Subject: WDNR Comments dated March 15, 2021 on the Site Investigation Work Plan (SIWP) Additional Investigation Sampling Plan, January 2021, Rev 1 and the Quality Assurance Project Plan, January 2021, Rev 0 Downstream Hayton Millpond Dam, Chilton, Wisconsin
BRRTS 02-08-587108

WDNR Comments on the Site Investigation Work Plan (SIWP), January 2021, Rev 1

WDNR Comments on the Quality Assurance Project Plan, January 2021, Rev 0

FIGURE 2

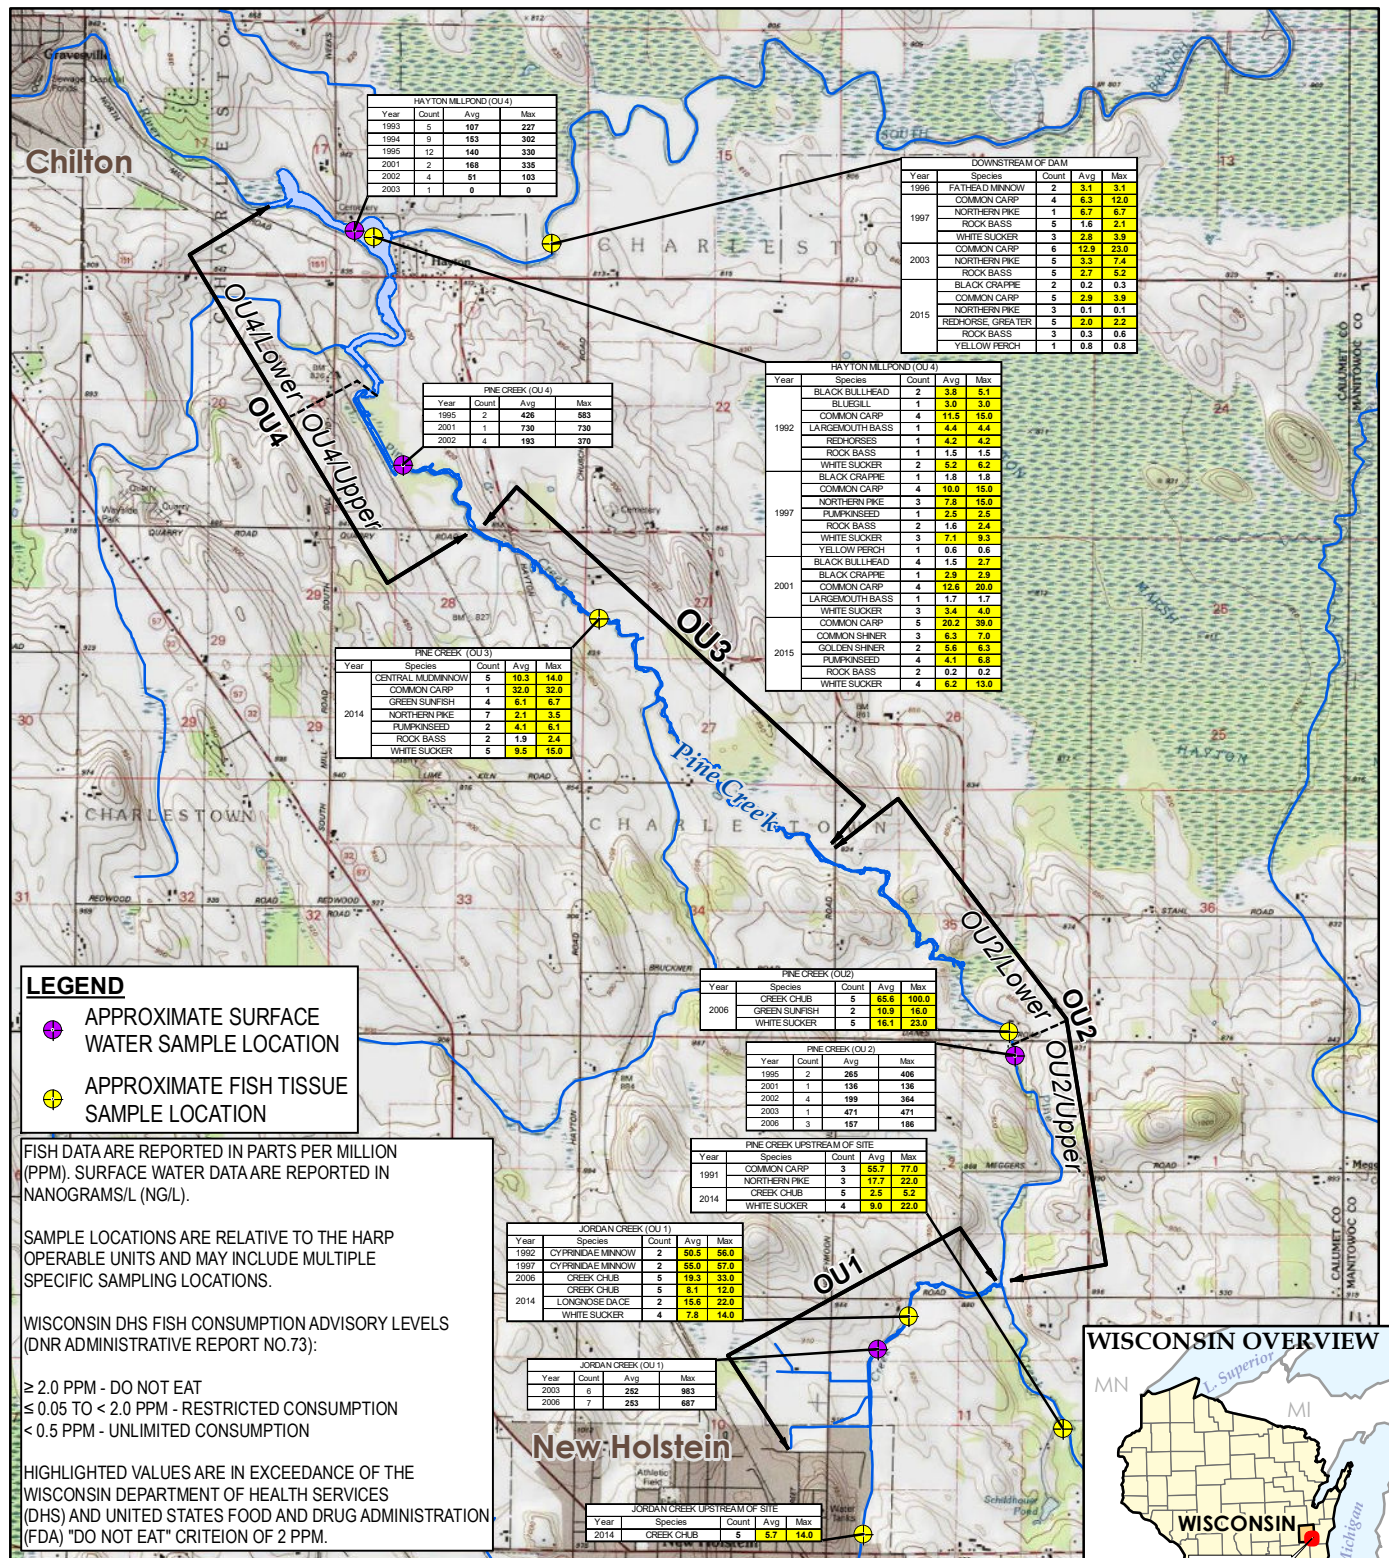
c. The sediment data collected in OU5 by the WDNR and TRC. Provide a map of these results.

18. *Figure 2 - Add stream distance on the map @ 100 ft intervals, show all sediment data.*

Response: The sediment data collected downstream of the Millpond dam by TRC and WDNR are now summarized in Table 1 and on Figure 2.

Response: Eight areas of bank scrape sampling will be performed, at locations noted on Figure 2. The 8 scrape sampling locations are at each of the 8 major bends in the river between the dam and 2 miles downstream. If this sampling indicates that bank erosion is potentially a source of PCB impacts to the river, scrape sampling will be performed at additional locations as part of an iterative investigation process. See, General Comment #2, above.

Response: Point bars have been targeted for sampling. The sample locations on Figure 2 are approximate. The sediment samples will be collected from an area of soft sediment deposit within 15 feet of the approximate location.

Response: Figure 2 has been modified to include stream distance markers and all existing sediment data from 2014 and 2015.
